**TOWN OF MOUNTAIN VILLAGE
REGULAR DESIGN REVIEW BOARD MEETING AGENDA
THURSDAY JUNE 6, 2024, 10:00 AM
MOUNTAIN VILLAGE TOWN HALL
455 MOUNTAIN VILLAGE BLVD, MOUNTAIN VILLAGE, COLORADO
TO BE HELD HYBRID THROUGH ZOOM:**

3.	10:02	15	Perez/ Applicant	Quasi-Judicial	Review and Recommendation to Town Council regarding a height variance for Lot 165 Unit 2, TBD Cortina Dr, pursuant to CDC Section 17.4.16.

4.	10:17	30	Perez/ Applicant	Quasi-Judicial	Consideration of a Design Review: Initial Architecture and Site Review for Lot 165 Unit 2, TBD Cortina Dr, pursuant to CDC Section 17.4.11.

5.	10:47	30	Nelson/ Applicant	Quasi-Judicial	Consideration of a Design Review: Final Architecture Review for Lot 926R, TBD Sundance Lane, pursuant to CDC Section 17.4.11. <i>This item was continued from the March 7, 2024, Design Review Board Meeting.</i>

C4

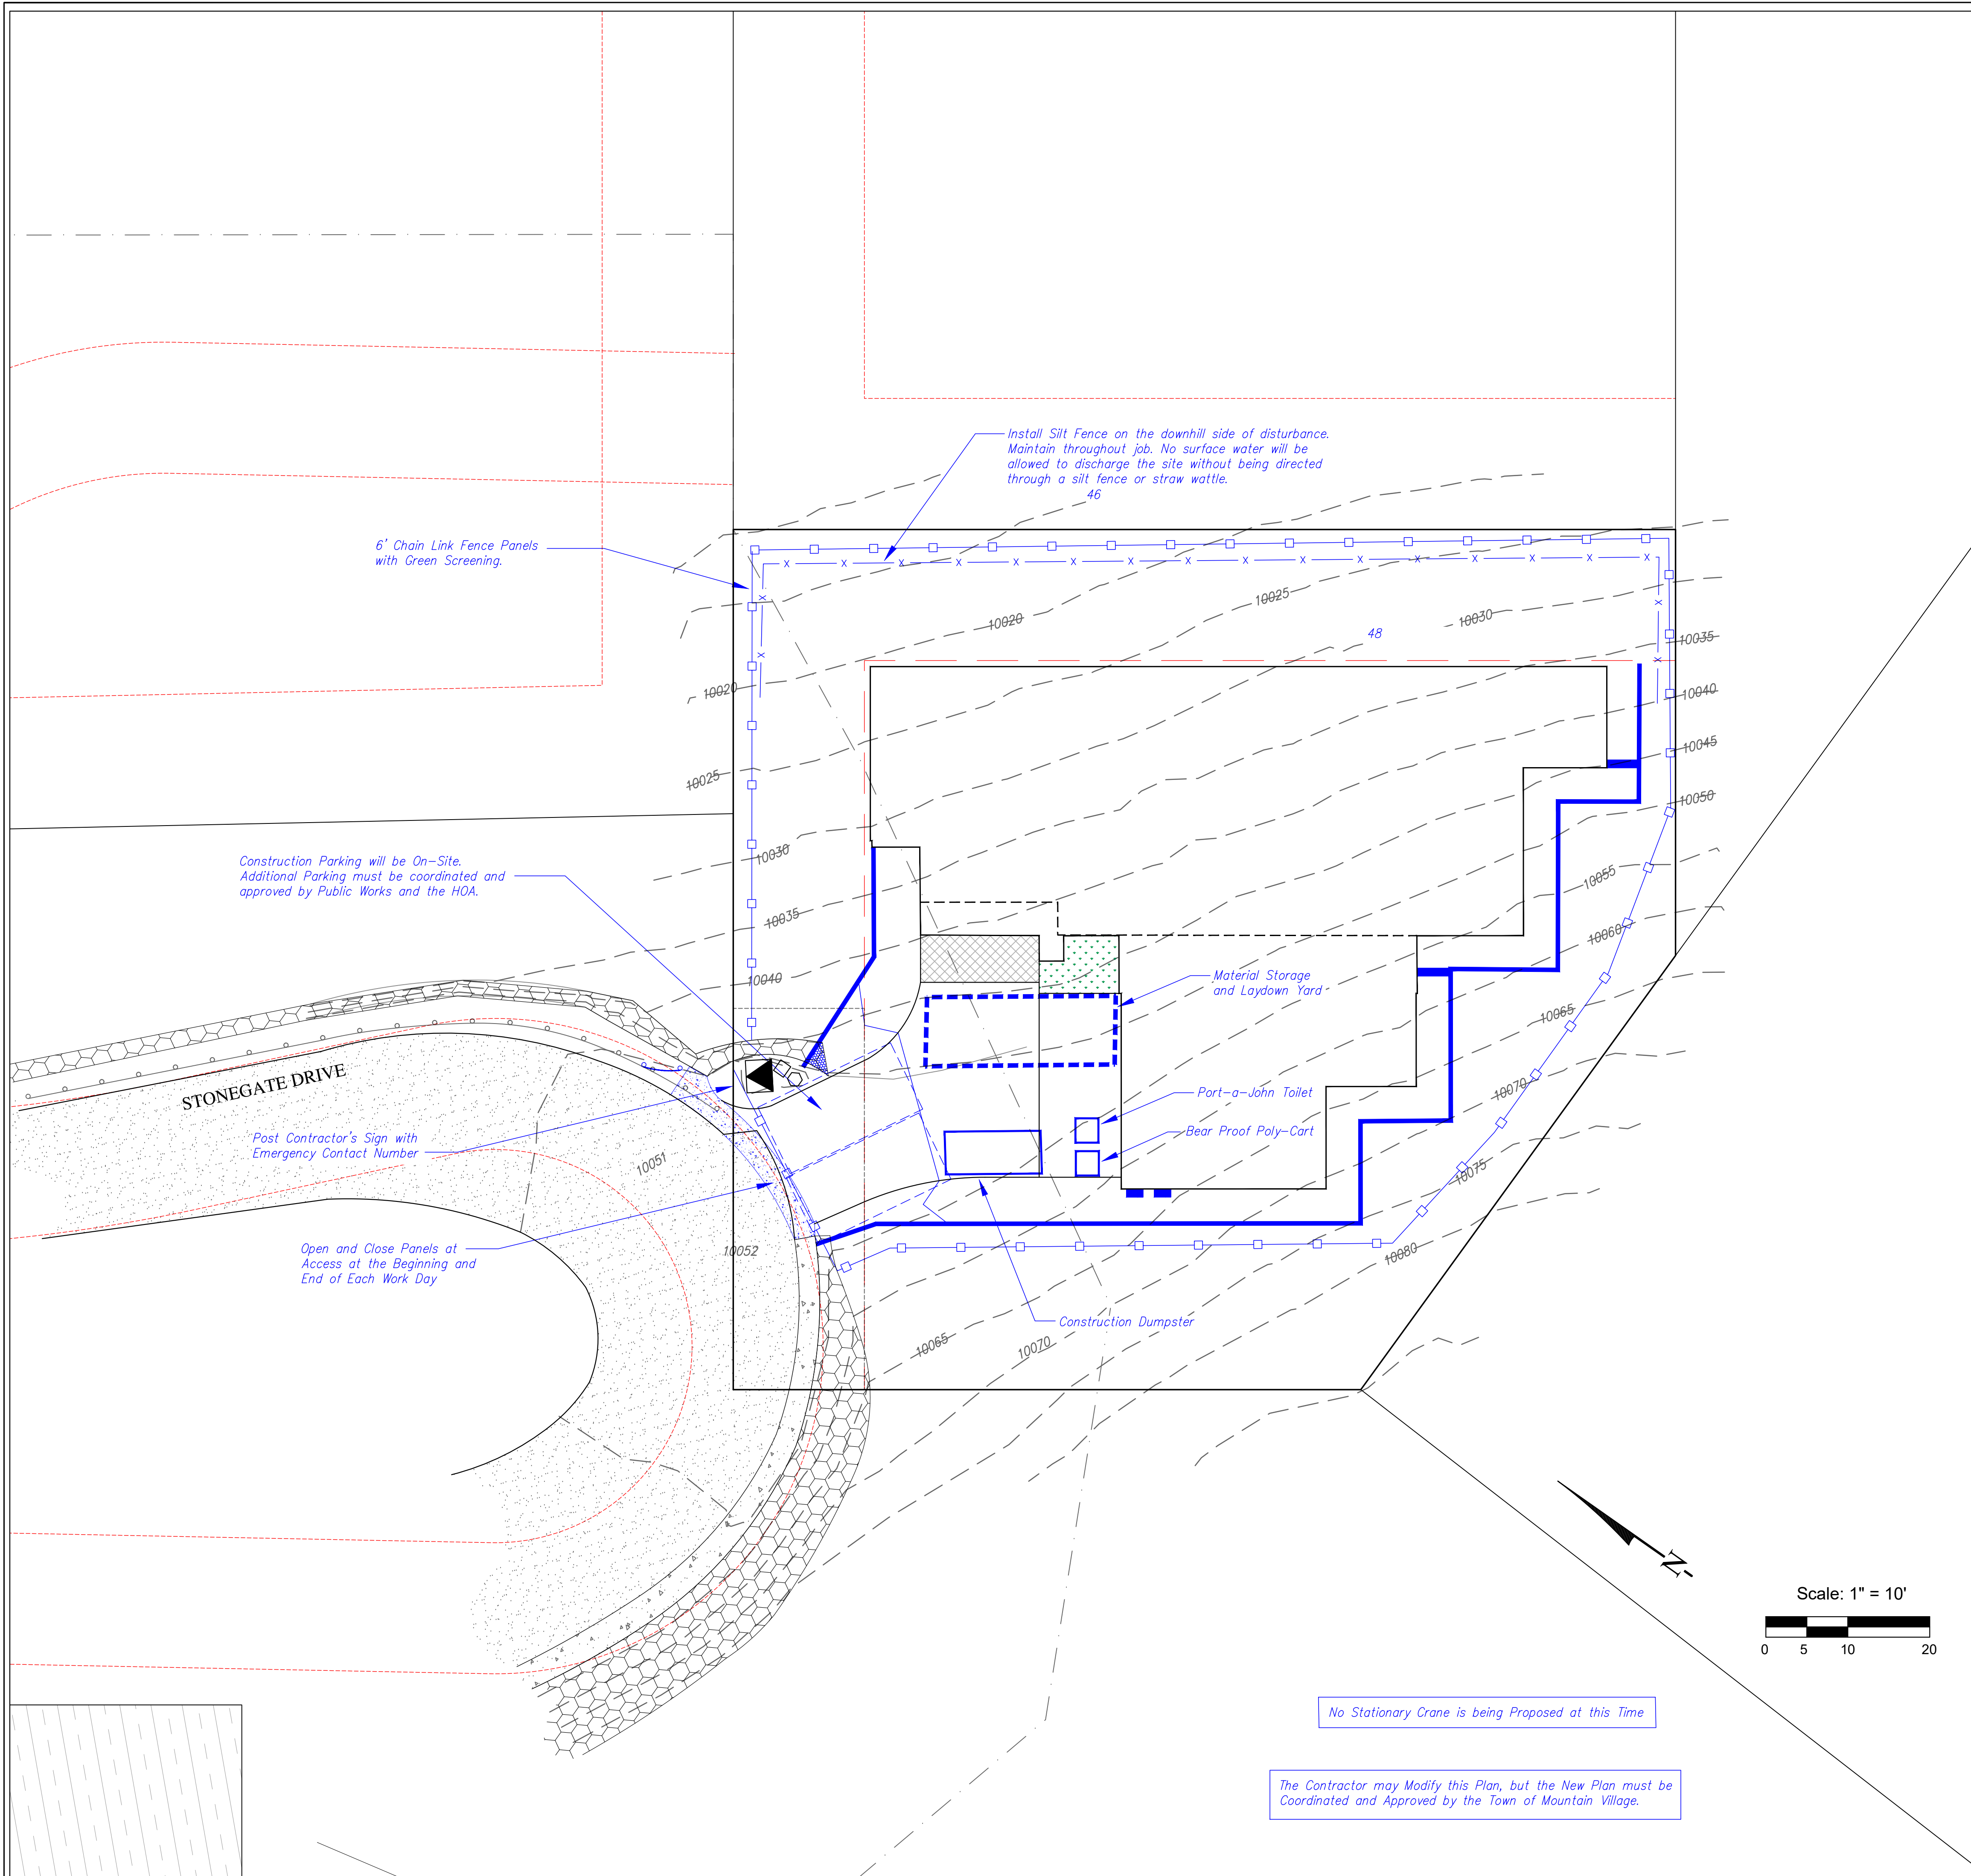
Construction
Mitigation
